June 2, 2009

Re: National September 11 Memorial and Museum – Parapet Design

Davis Brody Bond Aedas

NATIONAL SEPTEMBER 11
MEMORIAL AND MUSEUM
MARCH 27, 2009

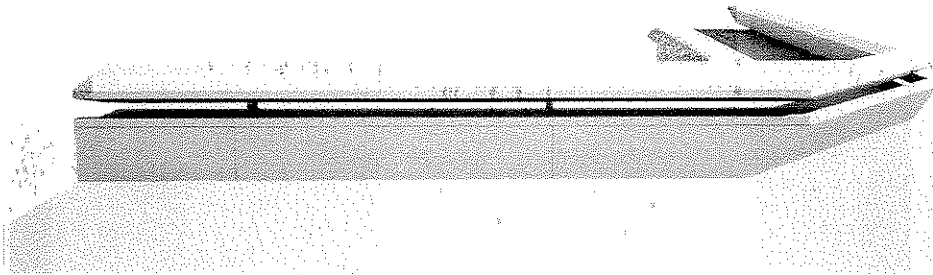
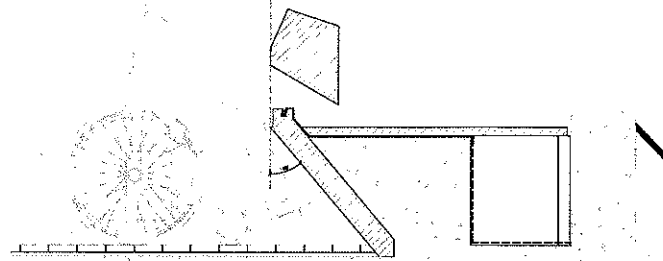
Based on your suggestions at the April 16th meeting, the parapet design was modified at the corners to meet the accessibility requirements in the code, and was presented to you again on May 11th. Sight-line studies on the modified design by Davis Brody Bond Aedas, the architects for the project, shows that the front view for the people on wheel chairs from the corners is equivalent to the view for others standing around the perimeter of the pools. In addition to the corners, the entire pool perimeter will be accessible for parallel viewing to achieve similar level of visibility.

Subsequent to our meetings, the Department of Buildings review has concluded that the modified design provides for 2 wheelchair front viewing positions at each of the four chamfered corners, for a total of 8 spaces at each pool, which meets the requirements in 2008 Building Code Section 1108.2, based on the following calculations:

Each side of the pools is approximately 200 feet or 2,400 inches
2,400 inches divided by 22 inches equals 109 standees per side
 $4 \times 109 = 436$ total standee capacity. Based on Table 1108.2.2.1, 6 wheelchair spaces are required. This is the code minimum requirement.
Considering a 2nd row of standees, the total number of people comes to $436 \times 2 = 872$.

The proposed 8 wheelchair front viewing positions are in addition to the parallel viewing locations available along the entire perimeter of each pool. Such arrangement will afford the wheelchair users the same viewing experience of people standing around the pool.

Furthermore, in the absence of specific standards or guides for sightline, the sightline analysis provided by Davis Brody Bond Aedas, pursuant to Title 28 Section 104.7.11, is satisfactory to the Department in demonstrating due diligence and that the proposed viewing locations meet the code minimum requirement. Accordingly, a waiver recommendation from the Mayor's Office for the Physically Disabled is not required.

50 PERCENTILE MALE & FEMALE AT PARAPET CORNER

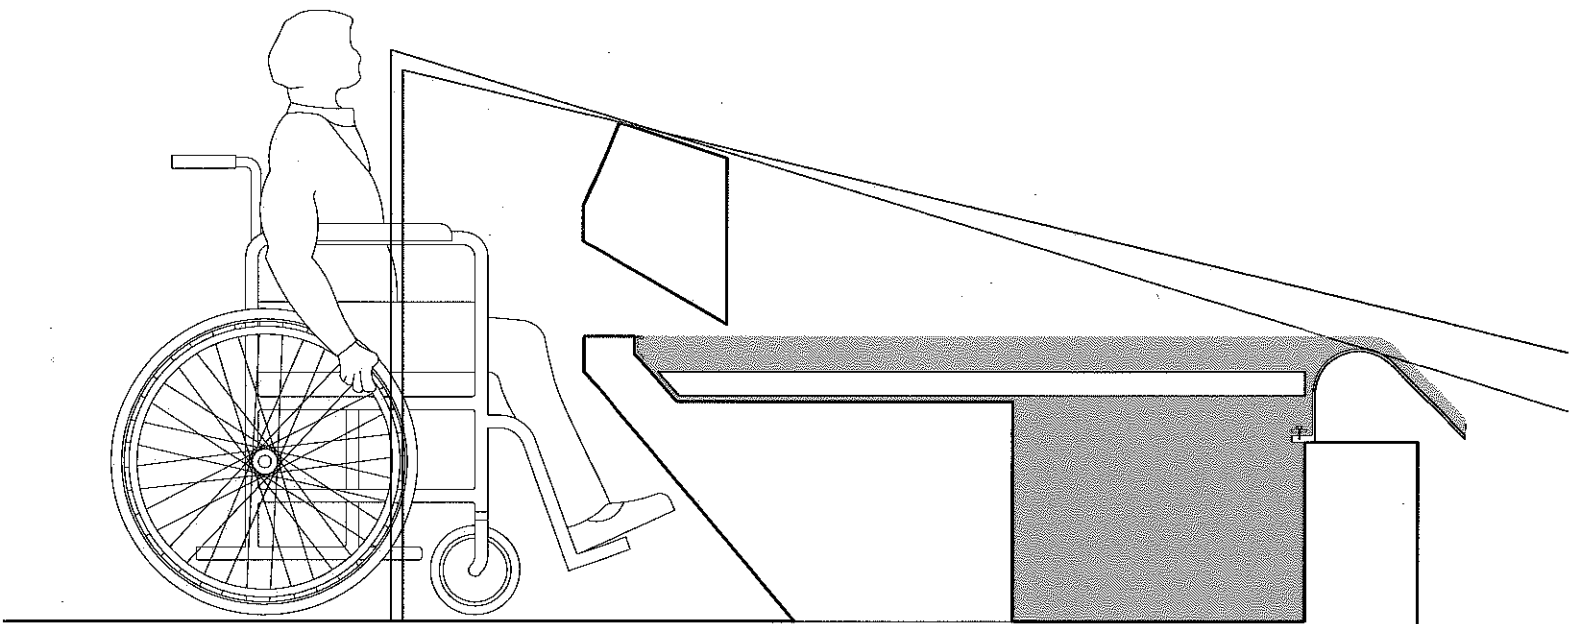
The results of the sightline studies indicate that mean (50 percentile) male and female wheelchair user have a view of the lower pools from the corners that is comparable to that of standing visitors elsewhere around the pool edge. This would also be the case for the 95 percentile of men and women.

5 PERCENTILE MALE & FEMALE AT PARAPET CORNER

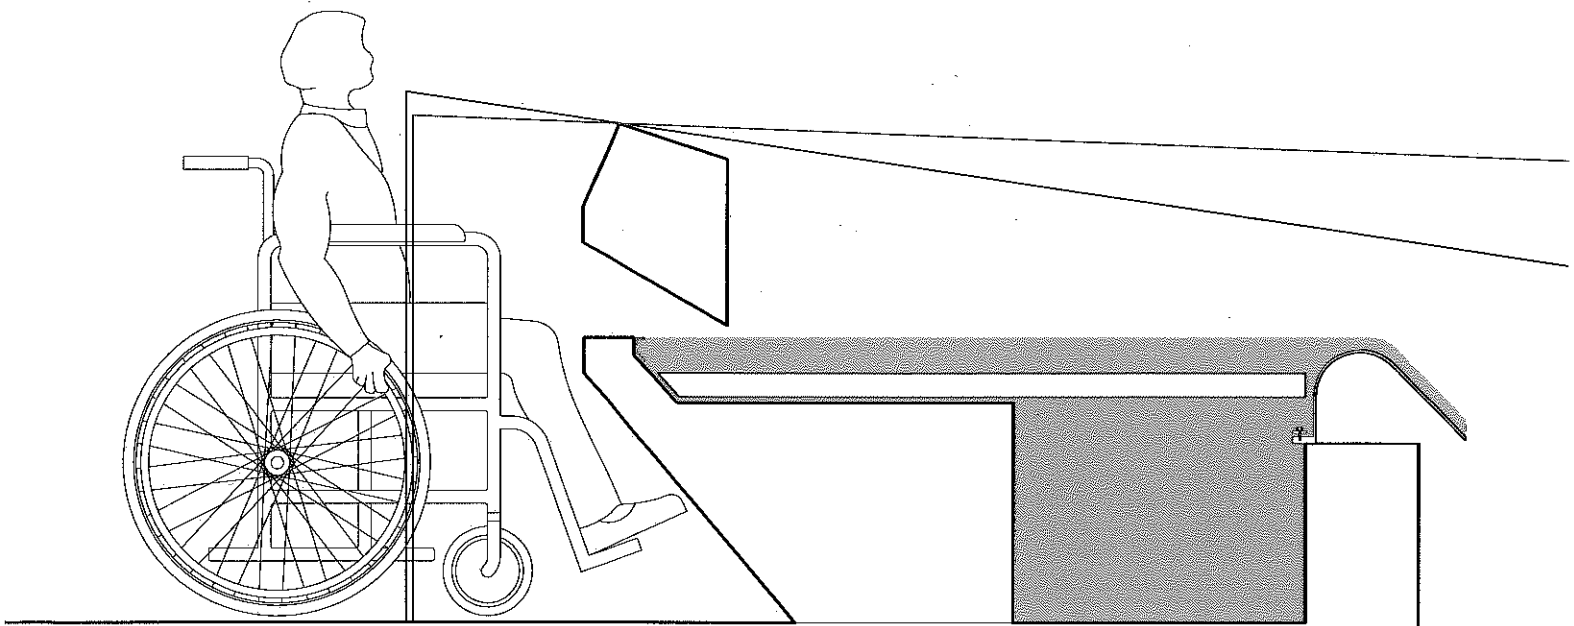
For wheelchair users who are considerably shorter than the mean (i.e. 5 percentile) it will be difficult to achieve a view into the pools comparable to that afforded able bodied individuals. Because of the eye level of these individuals (for example: female eye height at 42.7") it is difficult to look down into the void (though they are still able to see the waterfalls) and still maintain the code required 42" high guard around its edge. However, from the studies of the view achieved at the 50 percentile, one can reasonably conclude that the overall majority of male and female wheelchair users would have a viewing experience comparable to that of able bodied individuals.
